A G E N D A

Architectural Review Board

May 23, 2017

Proposed Addition
to Laundry Room

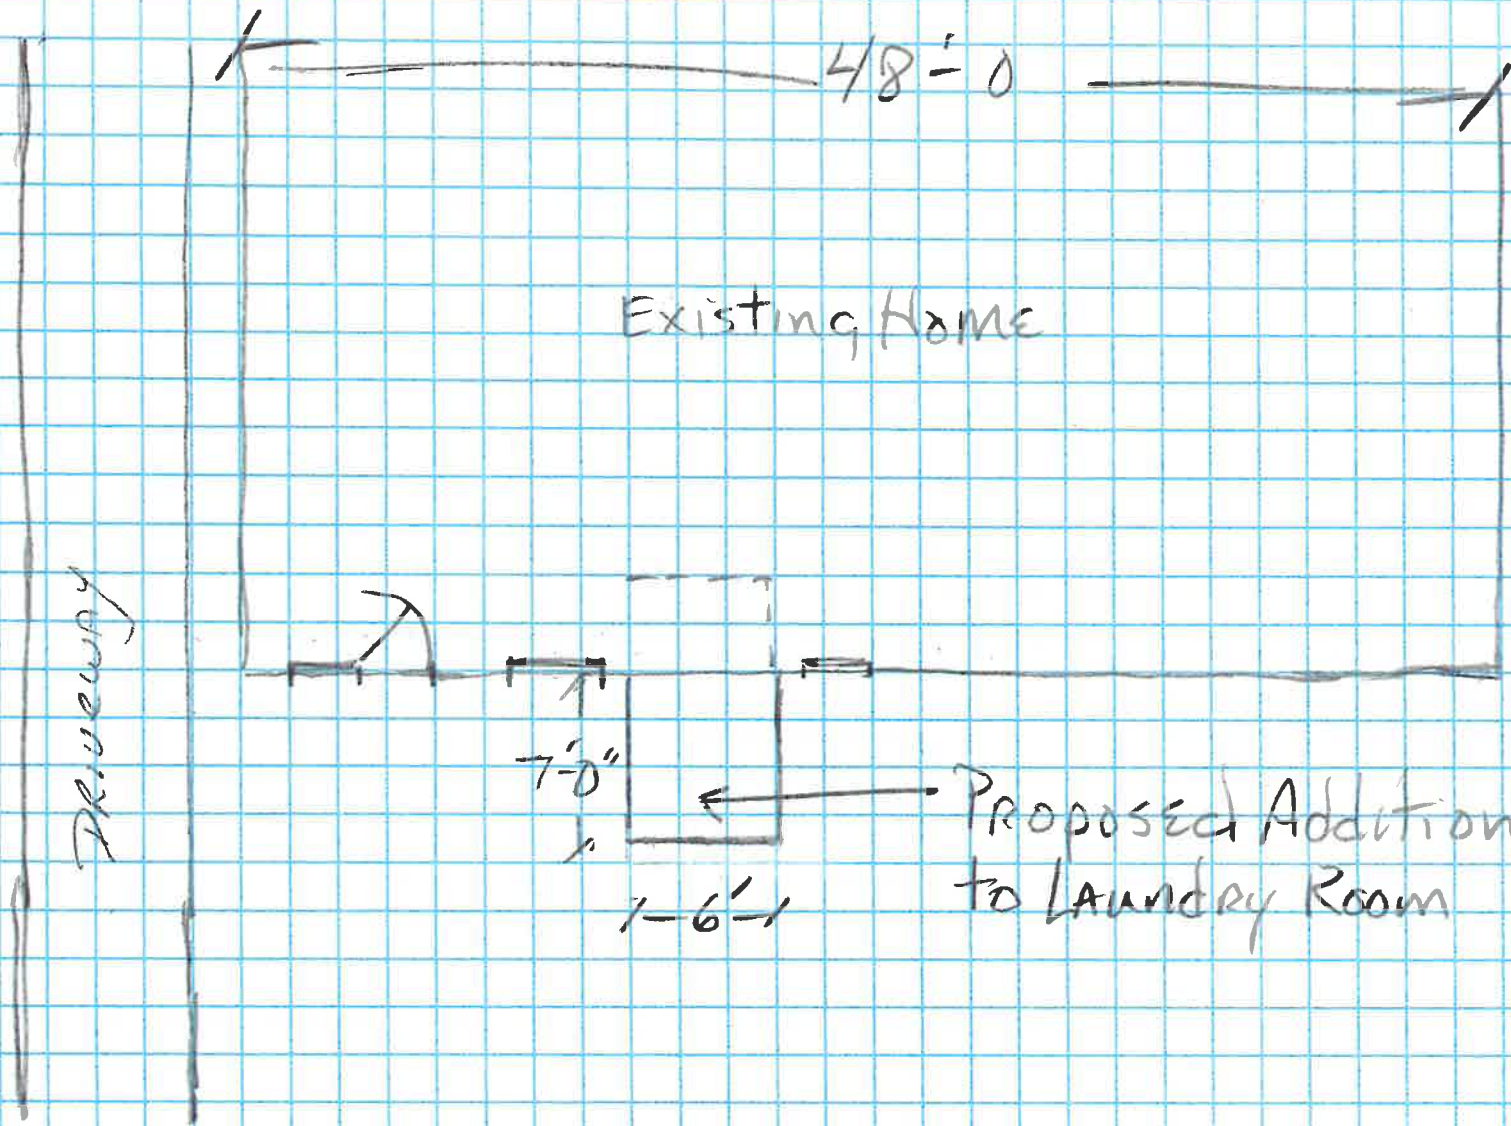
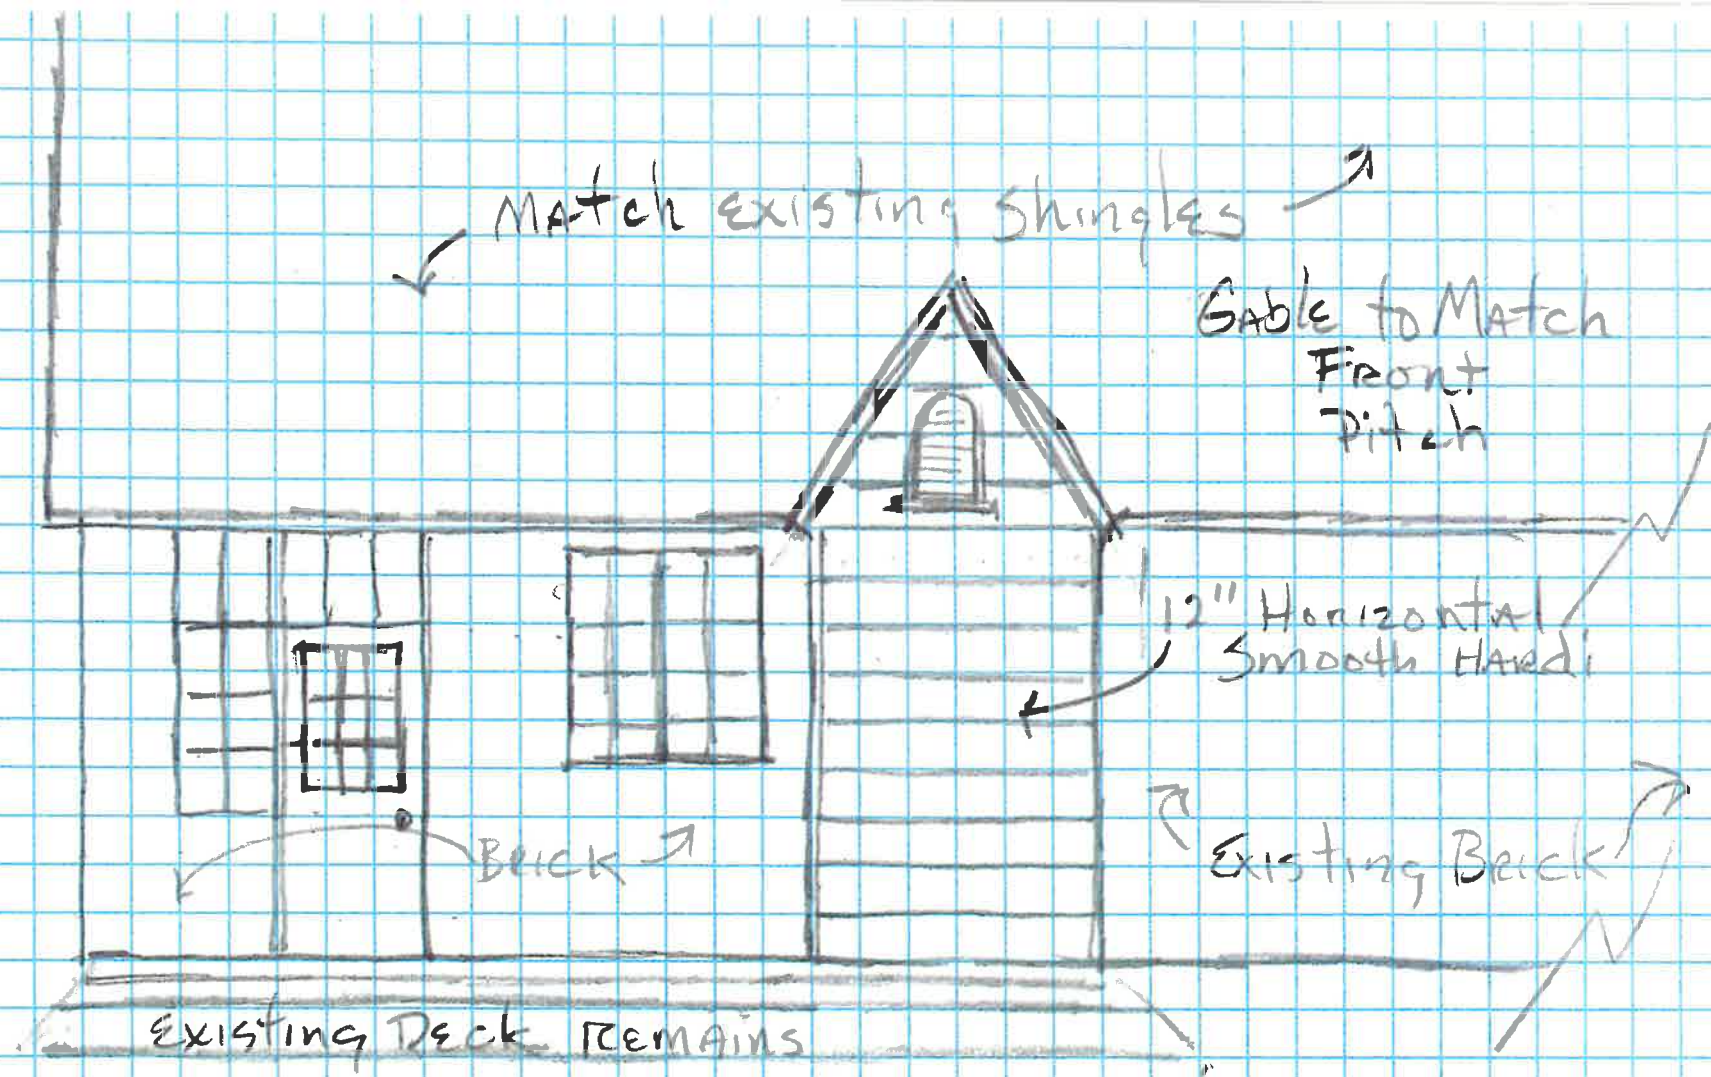
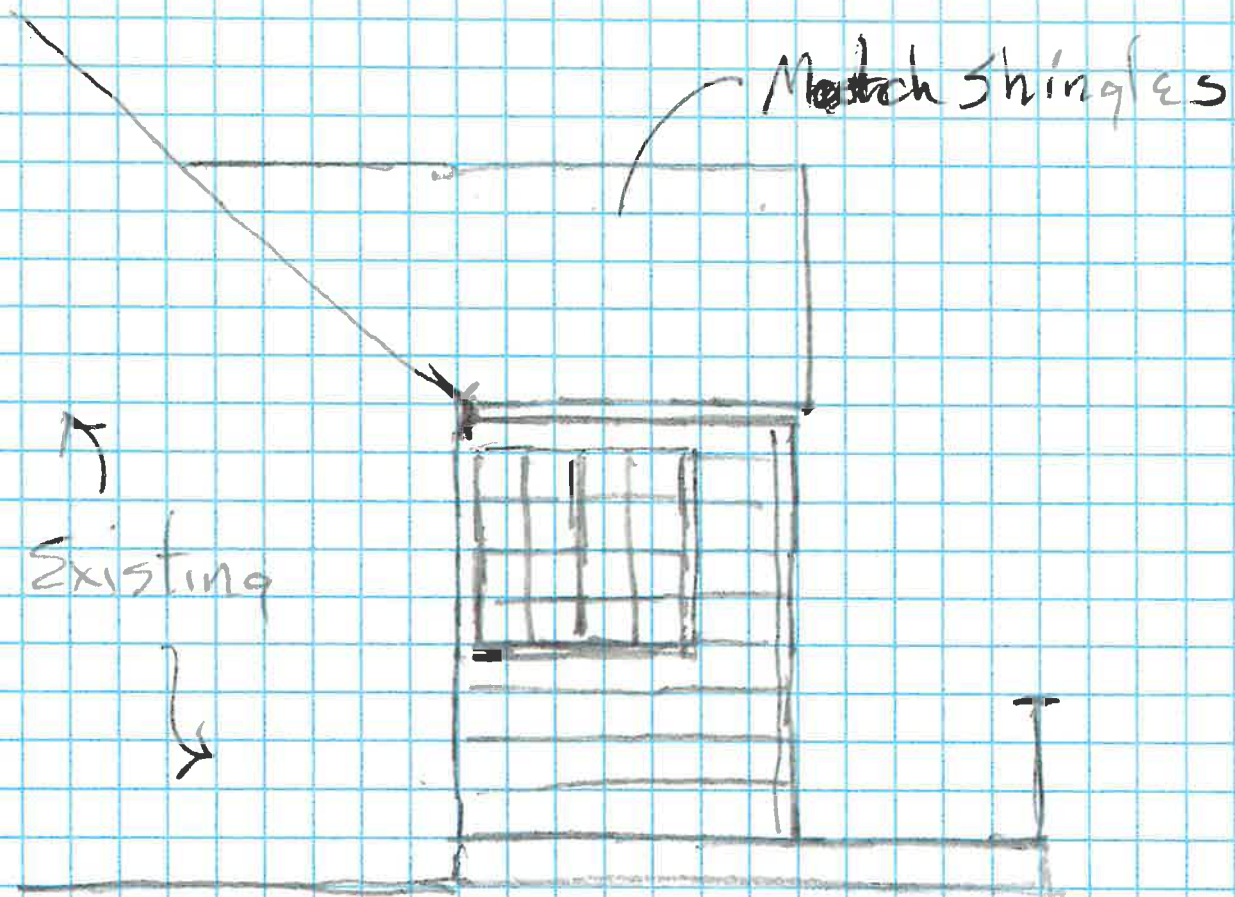
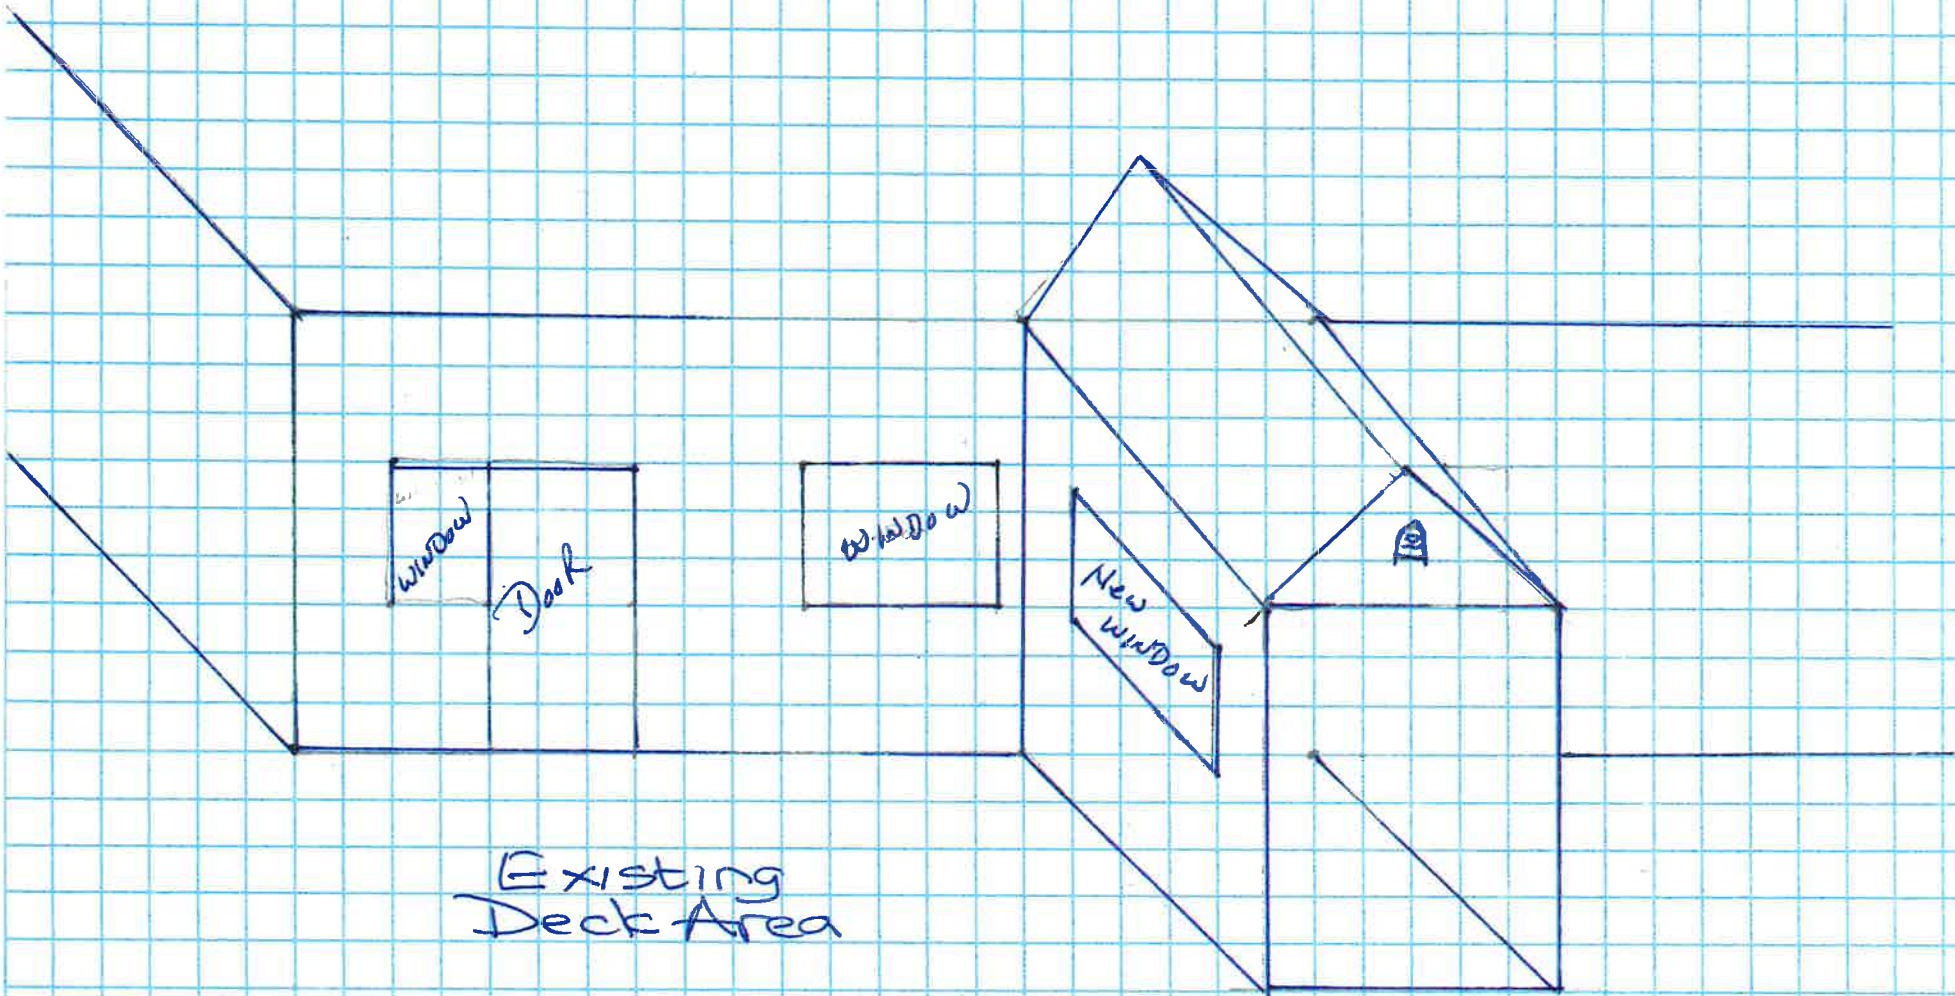
- The addition will not be visible from the street. The house is brick veneer, the addition would be differentiated (as recommended in the Secretary of the Interior's Standards) from the original construction by using the different material.

STRUCTURAL OBSERVATION MEMO

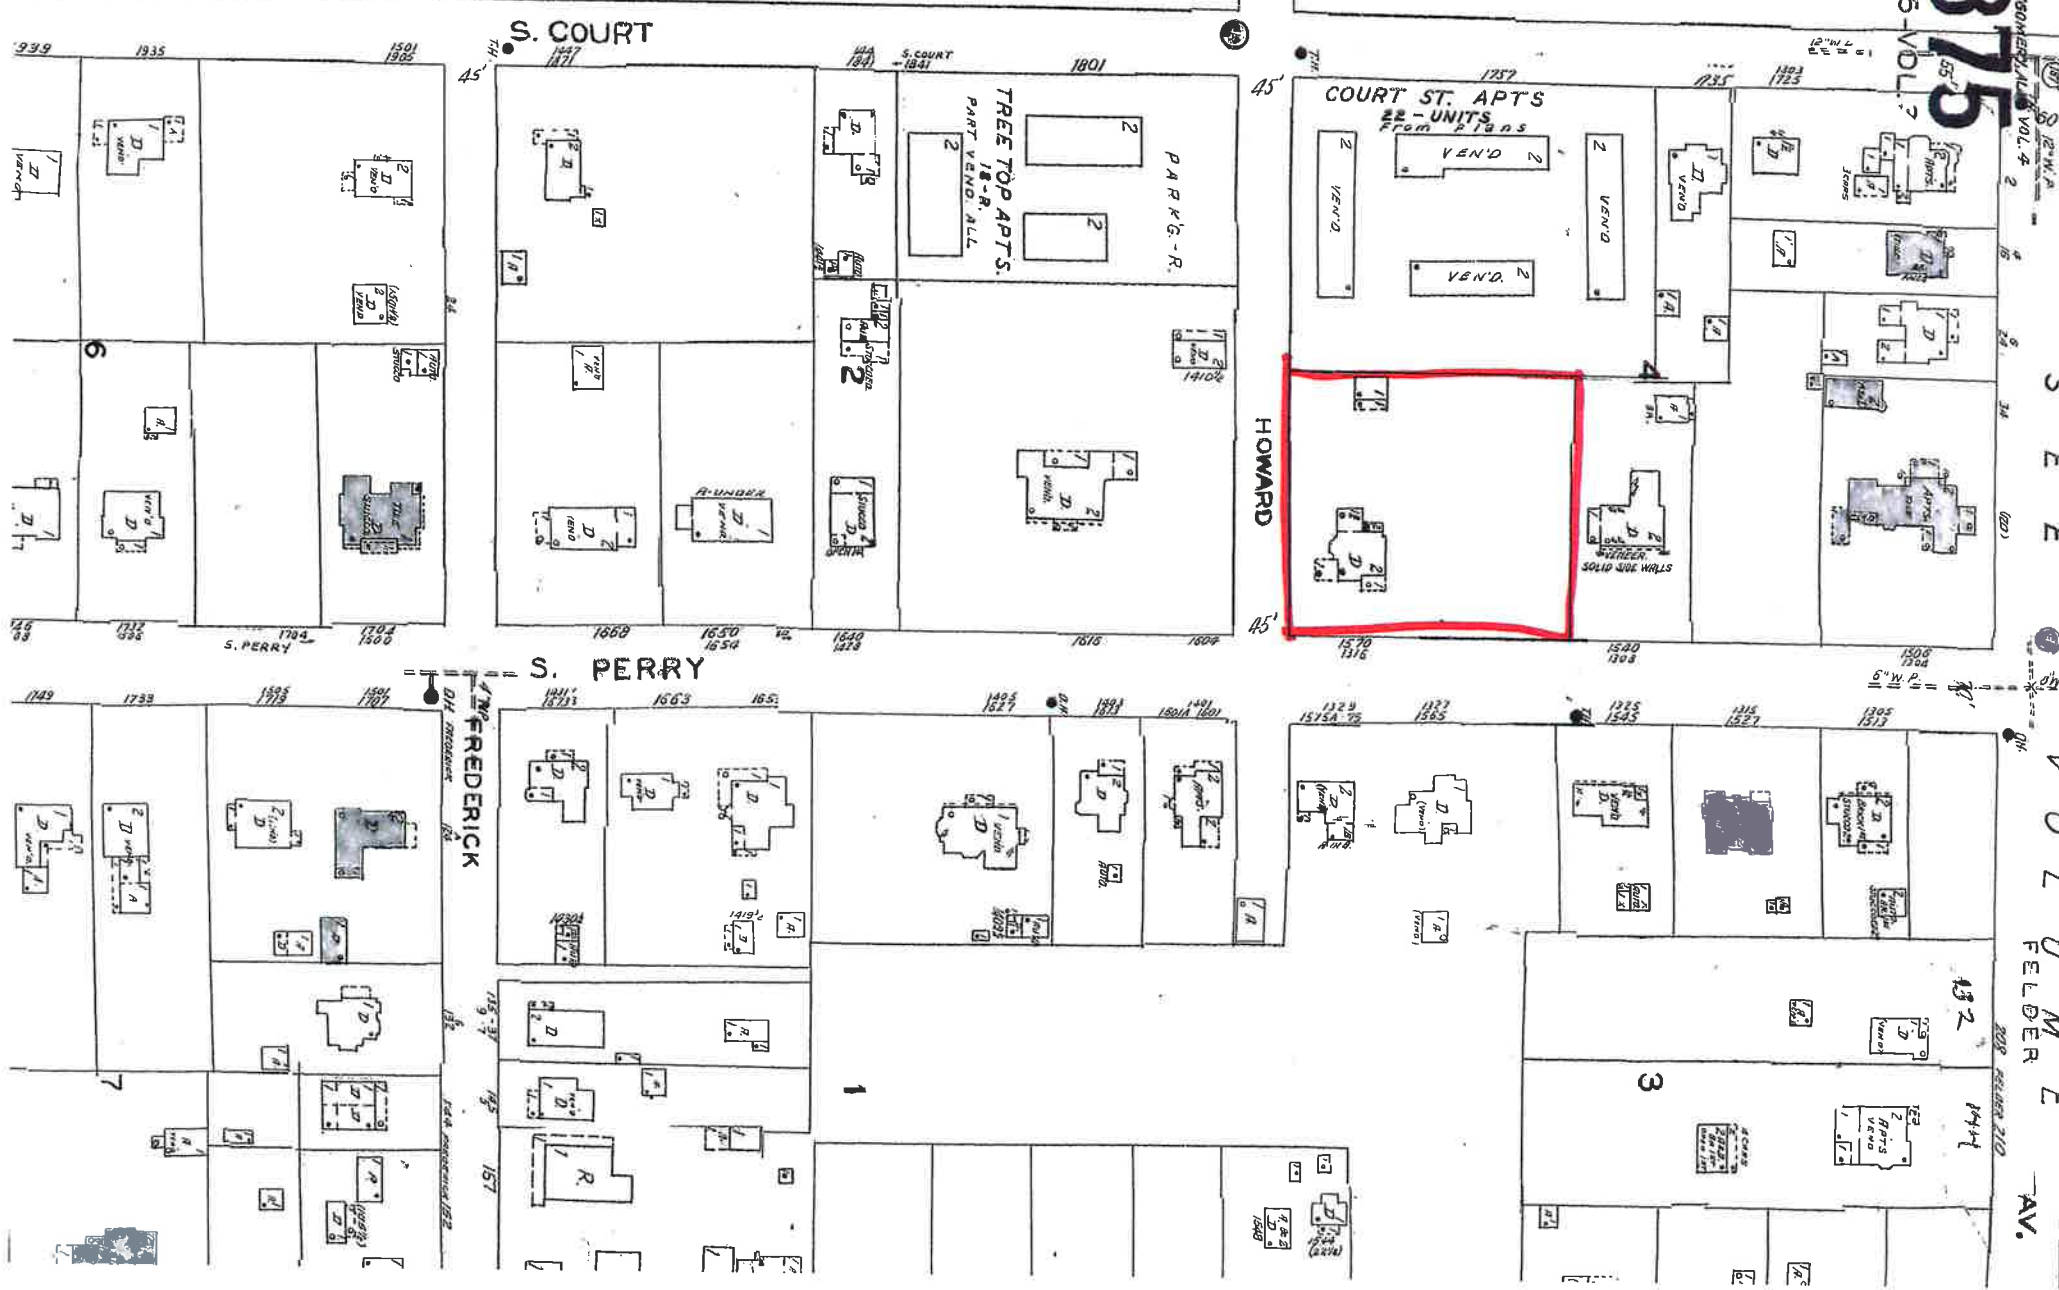
- The porch roof appears to have a very low slope, probably too low for the shingle covering. This apparently has contributed to water leaks that have damaged the wood finishes and wood framing in some areas.

- The beam on the east side of the porch that is covered with finish boards has a significant sag in the center. This is likely due to some water damage or possibly an undersized beam.

- The corresponding beam on the west side of the porch does not have a significant sag but the north end has dropped significantly where it goes into the house wall for support. There are significant signs of water leaks and rot at this location. It appears that the beam end has rotted and much of the support has been lost. This requires repair and should be considered as a serious condition.

- Our recommendations are to shore the ceiling joists on each side near the beams, remove wood finishes and replace the existing east and west side beams doing one side at a time. The shoring design is the responsibility of the contractor. The span is over 21 feet so we recommend using (2) 14" deep LVL beam on each side. These LVL beams should be painted for additional protection before placing new finish boards. Verify that these new

beams have adequate bearing on at least double studs in the house wall. Additional support framing may be required. The south ends of these beams should bear fully on the existing large diameter steel columns.

- Once these new beams are in place the damaged roof deck, rafters and ceiling joists can be reworked as required. The extent of this damage to secondary framing is unknown but appears that it may be fairly isolated to the northwest corner and possibly along a portion of the east side.
- We recommend the existing or repaired roof deck be covered completely with ice and water shield and then an acceptable finish roofing.
- Due to the historical nature of the home the final appearance after repairs should be essentially the same as the original appearance.
